# CITY OF ALBUQUERQUE

**RE: Entertainment Facility  
3930 Pan-American NE  
Grading and Drainage Plan  
Engineers Stamp Date: 2/1/18  
Hydrology File: G16D145A**

Based on the information provided in your submittal received on 2/2/18, the Grading and Drainage Plan cannot be approved for building permit until the following are addressed:

PROPOSED BASIN MAP

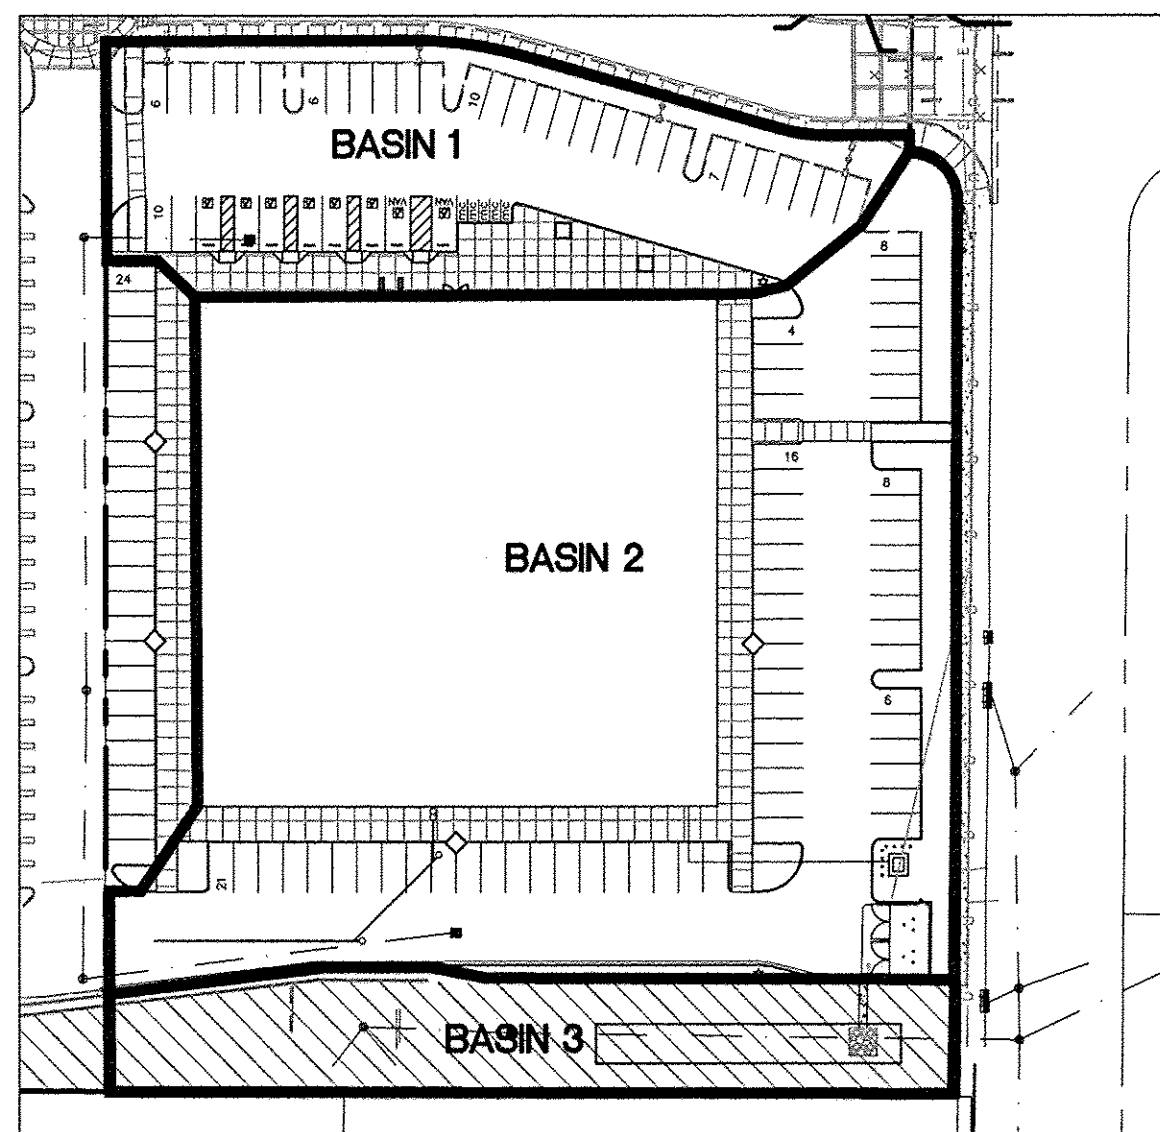
1. The western edge of this project site is not delineated as a subbasin and does not appear to be considered in your drainage plan. Please include.
2. Hatch or otherwise delineate the impervious versus pervious areas on the subbasin map and provide the areas for each. Include a scale for the subbasin map.

3. This site has been previously graded and compacted by human activity; no type B land treatment remains. Please update to reflect land treatment C.
4. Calculate the first flush requirement for each subbasin and show how it will be retained on-site for each subbasin. If unable to retain on-site, the bypass volume needs to be quantified and stated on plans. Payment of Fee-in-Lieu will be required for the bypass volume at a rate of \$8/CF.

5. Basin 2 is described as surface draining south into the drainage channel. However there is an existing inlet in the proposed parking lot that drains to the west. Will this be removed?

6. Who owns the southern drainage easement? Assuming this is a publicly owned easement, the proposal to use it as a first flush facility is unacceptable and an alternate site needs to be selected for first flush ponding. The City will not accept maintenance responsibility for private first flush ponds.
